SERVICE BULLETIN

SUBJECT: **MODIFICATION OF SRIS PIPING**
Affected Models: **GT750**

Bulletin No. **117**
Date **Jan 16, 1973**
Page **1** of **3**

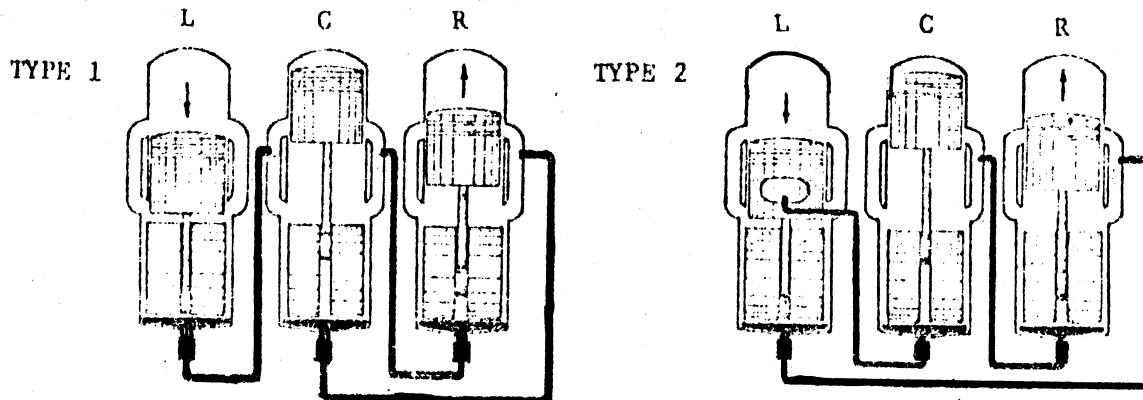
As explained in the Service Manual of GT750, there are two types of the SRIS piping shown below and the type 2 in the illustration has been applied to the production since just before the yearly change of 1973 and the initial number of the modified engine is GT750-31344

The reason for this modification is to rectify the symptom that the engine of the type 1 tends to emit a little thick fumes from the right hand muffler as compared with the others

This symptom only appears when the engine is not warmed up enough and it in no way affects the engine function. However, it is supposed that the users who mainly drive the motorcycles in town or at rather low speeds might point out this problem and request you to correct it.

In order to provide for this request, a modification kit has been prepared to convert the early engine to the new type in principle and it now available as a spare part.

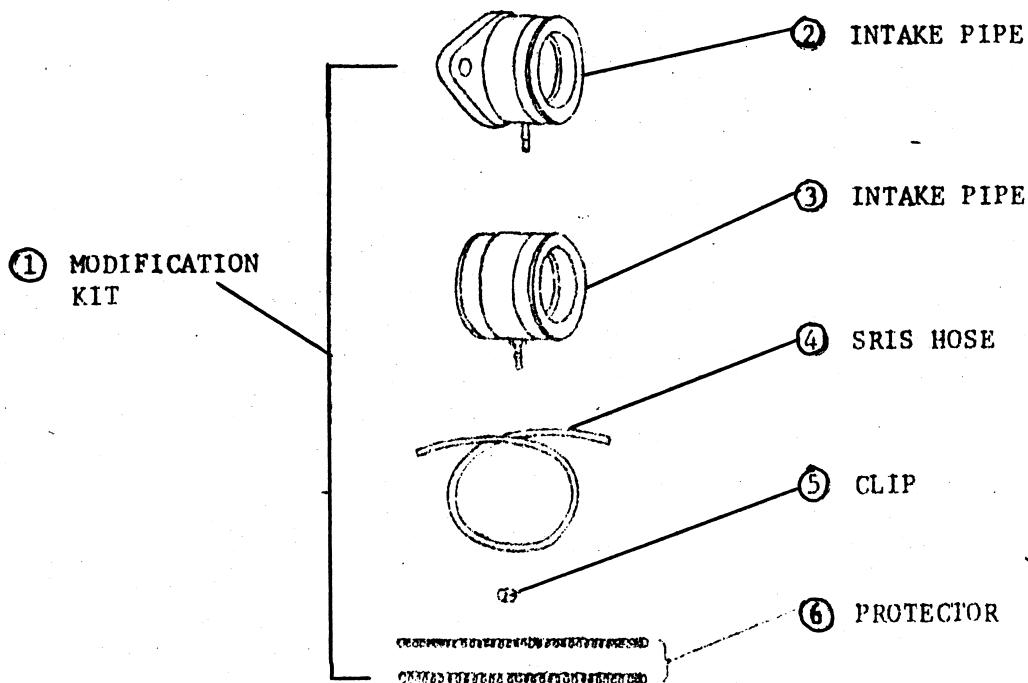
The modification kit includes the following parts:

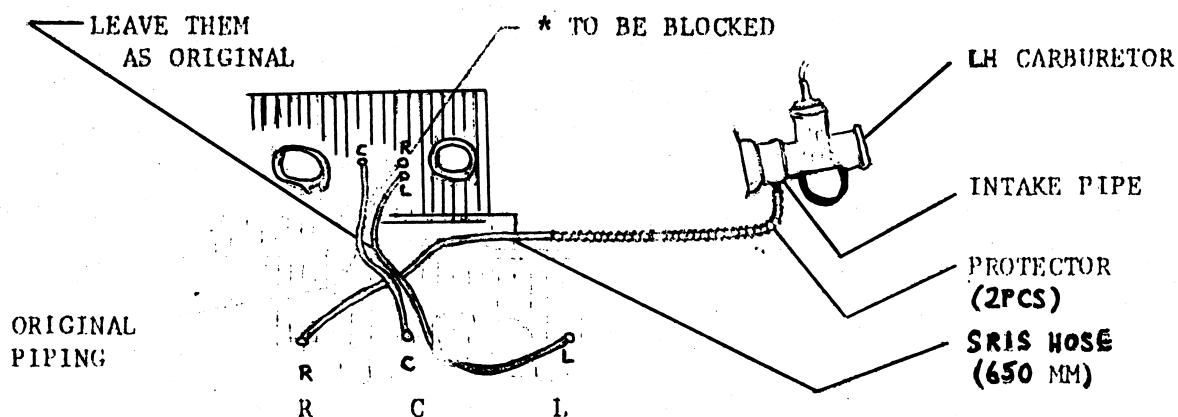
Since the early type engines are classified into two types in respect to the configuration of the intake pipe placed between the cylinder and the carburetor, the modification kit has been provided with two types of intake pipe so that it can be used on both types. Therefore it is necessary to check the type of the engine and use the appropriate intake pipe.

MODIFICATION PROCEDURE

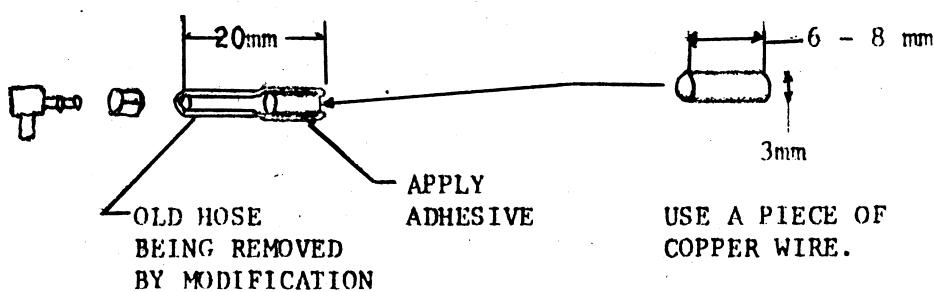
* To block the part shown above, perform the following job.
